<b>MRPL Marketing Terminal Project at Devangonhi, Bangalore Marketing Infrastructure Projects, MRPL.</b>	
<b>LSTK-A PACKAGE : TANKAGE AND ASSOCIATED CIVIL, MECHANICAL, PIPING, ELECTRICAL, INSTRUMENTATION &amp; FIRE FIGHTING WORKS ADDENDUM 04</b>

## ADDENDUM 04

### MRPL Tender No. 3200000495 dated 26.03.2021

**TENDER FOR: TANKAGE AND ASSOCIATED CIVIL, MECHANICAL, PIPING, ELECTRICAL, INSTRUMENTATION & FIRE FIGHTING WORKS  
(LSTK-A PACKAGE) MRPL MARKETING TERMINAL PROJECT  
AT DEVANGONTHI, BANGALORE MARKETING INFRASTRUCTURE PROJECTS, MRPL**

DRAWING TITLE: **SCHEMATIC OF MRPL WORKS IN PMHBL MANIFOLD AREA**

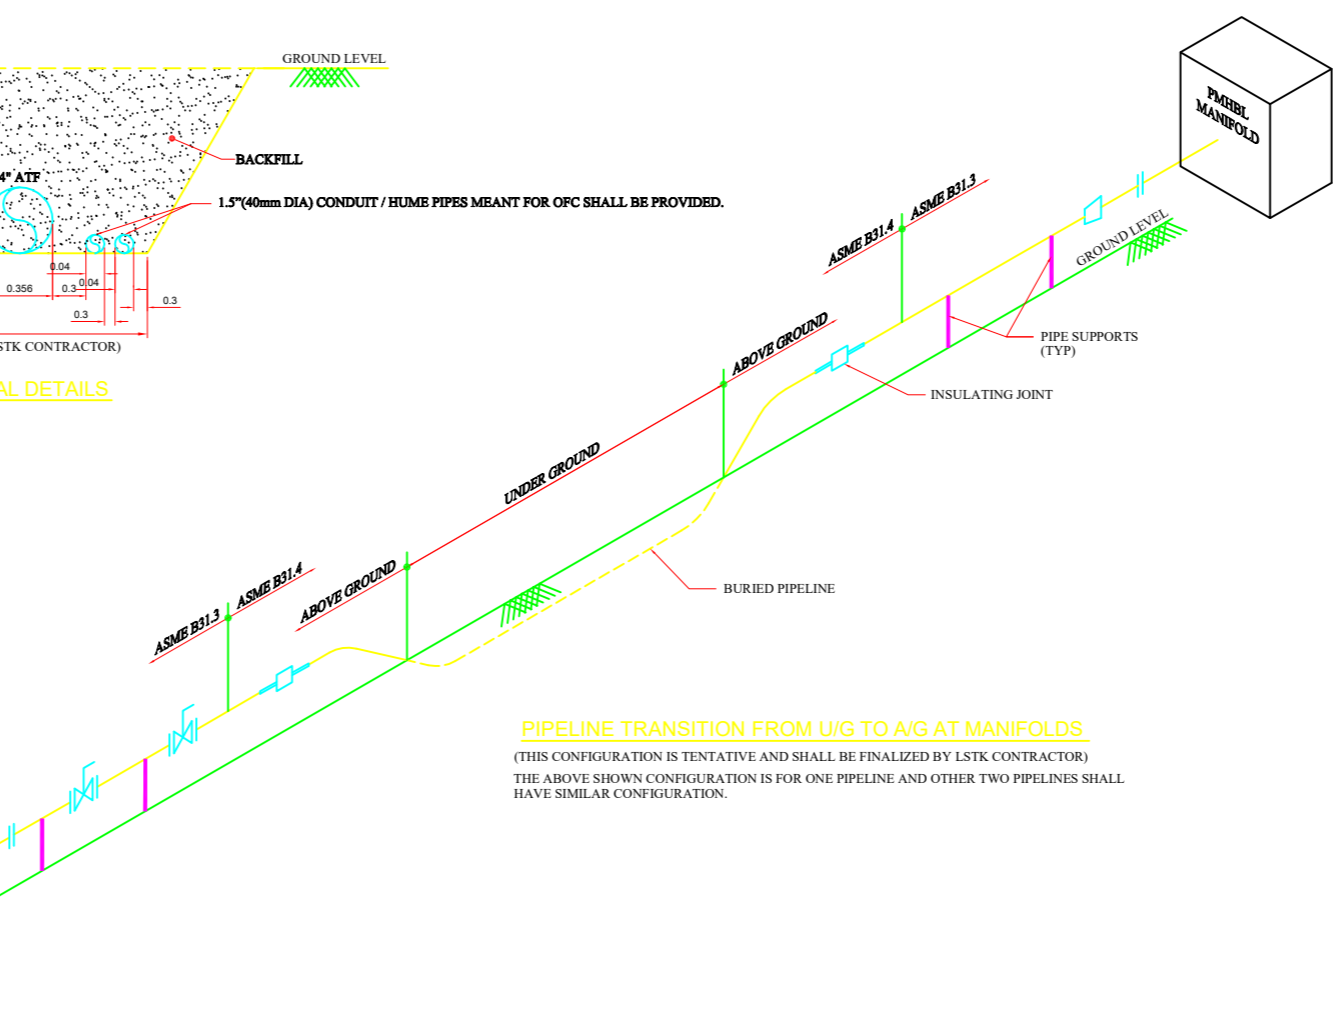
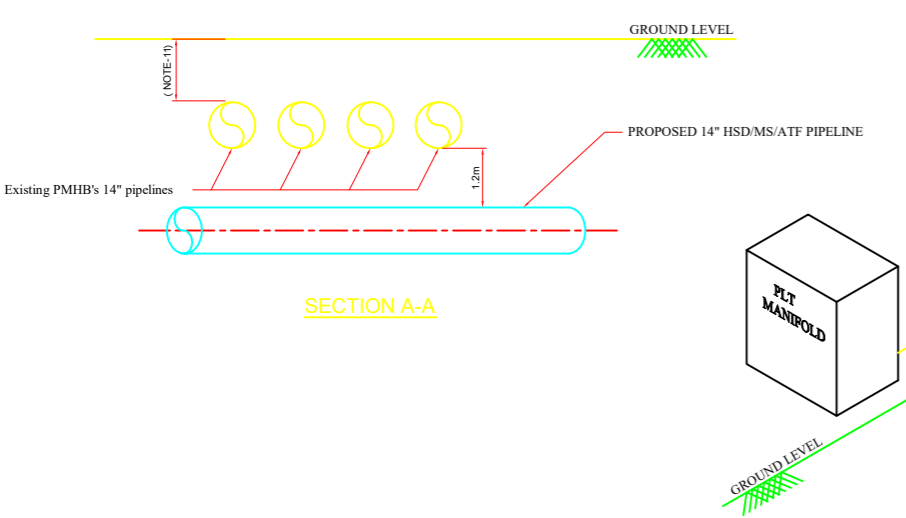
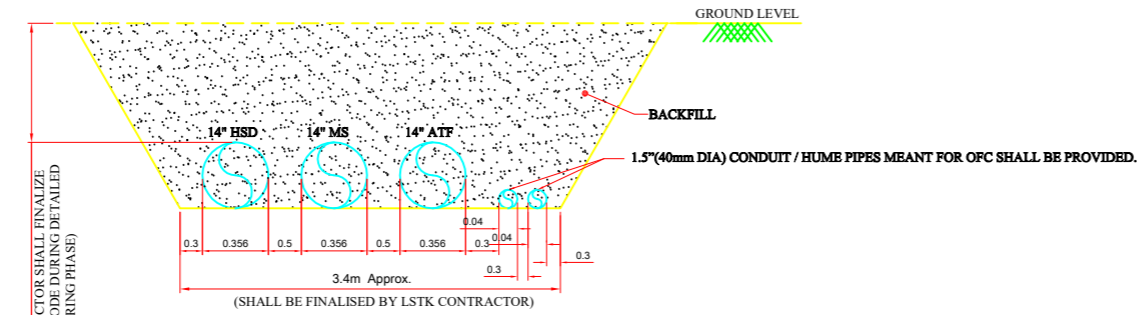
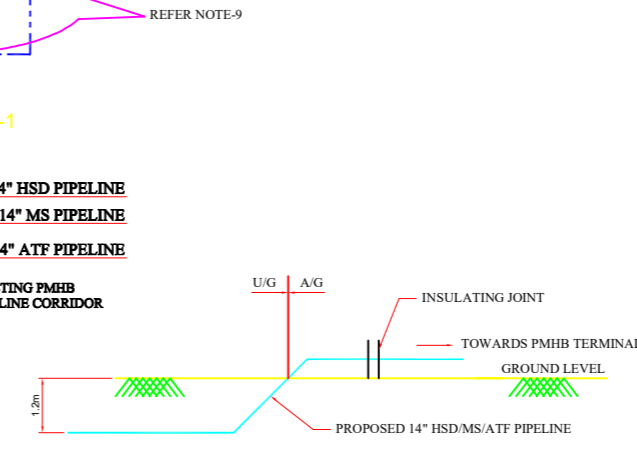
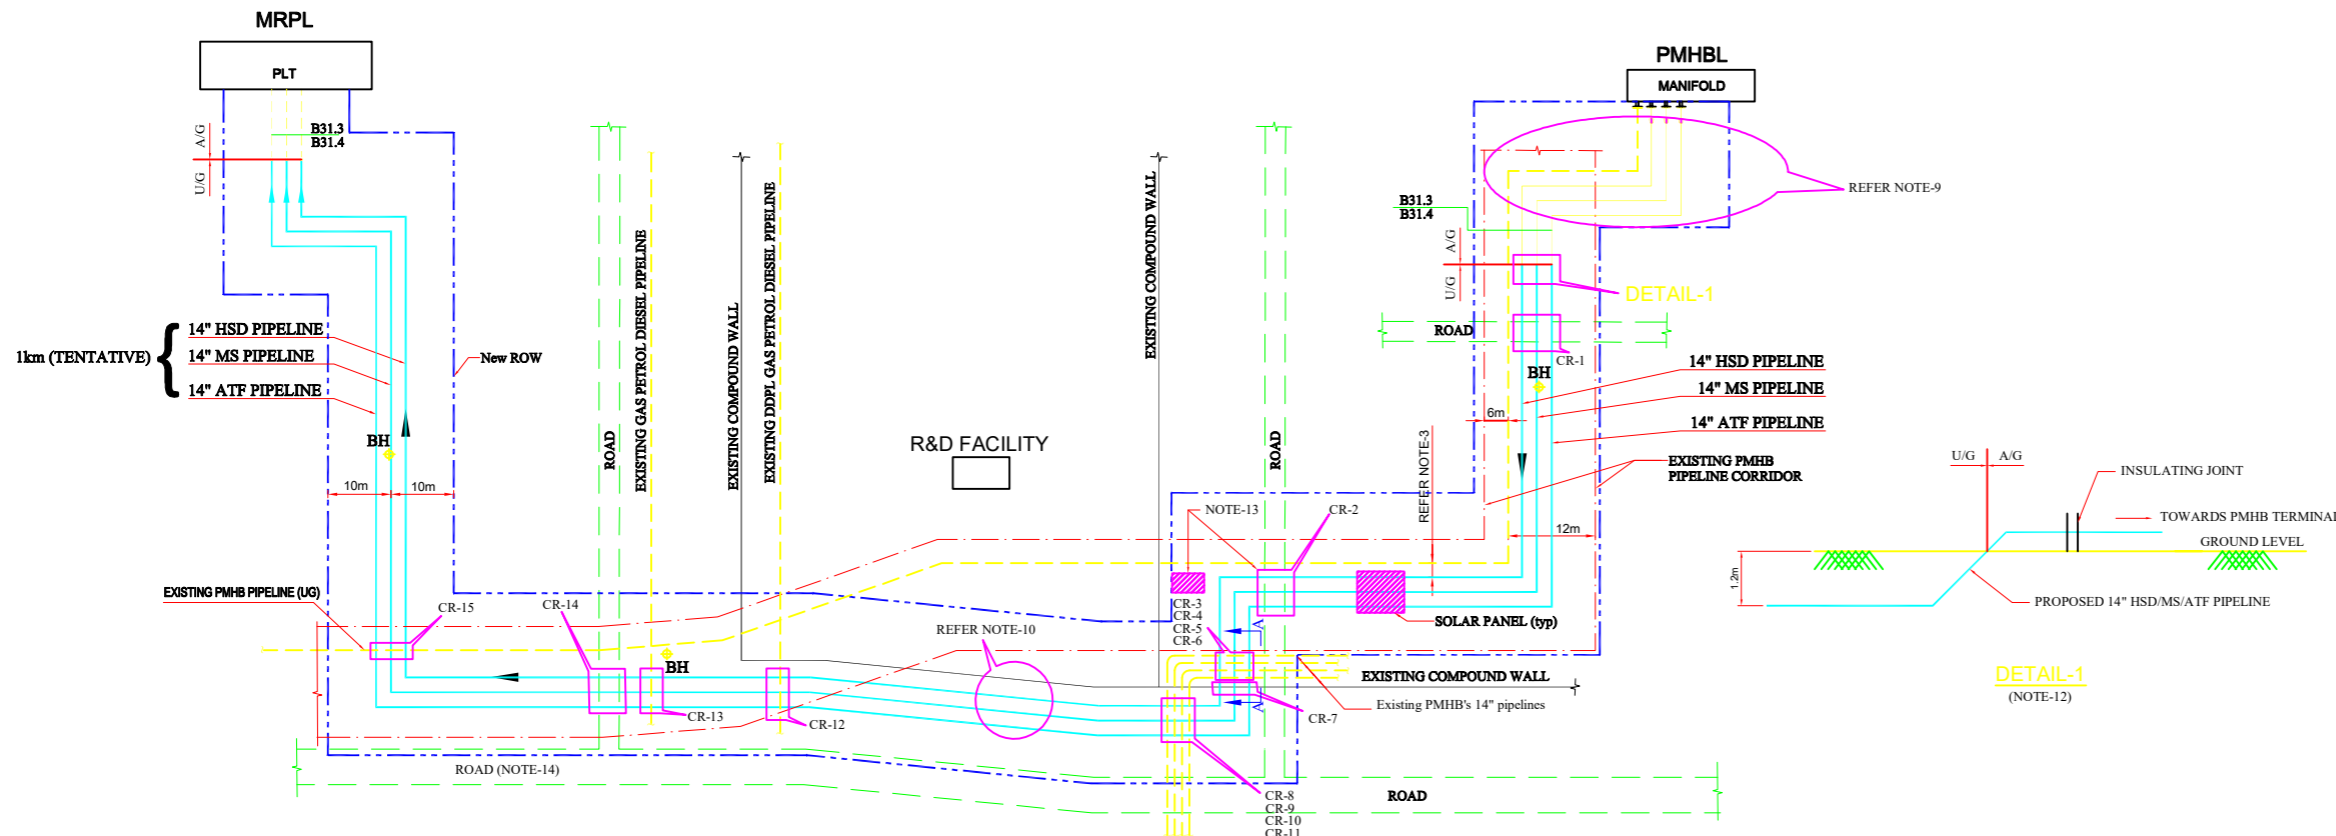
Sl. No.	Volume	Section No./Clause No.	Page No.	Existing Tender Clause	Addition / Deletion / Modification
	Section Part 30				<b>“20005-GEN-PL-SK-0001, SCHEMATIC OF MRPL WORKS IN PMHBL MANIFOLD AREA, SHEET 1 OF 2. Rev 0.</b>
